VISION PROFILE EXTRUSIONS

Sample Approval Form

Die #: 15901C
Description: SH / SS WINDOW FRAME
Rigid Colour: WH-115
Flex Colour: N/A
Capstock Colour: BLK-3300

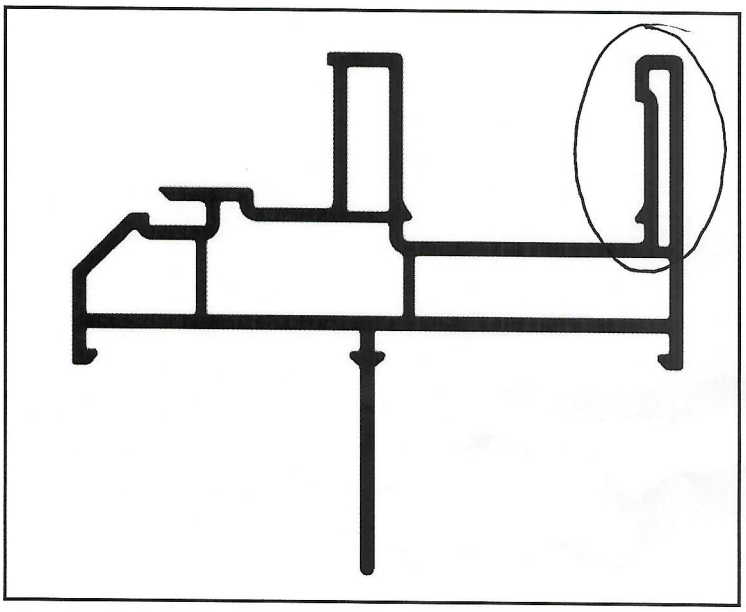
Comments: Sample is approved, however the wall circled in the picture above is not as straight as we would like. The wall seems to be leaning into the pocket slightly, making some dimensions .010" out of tolerance. We would like to see what can be done to make sure this wall stays straight.
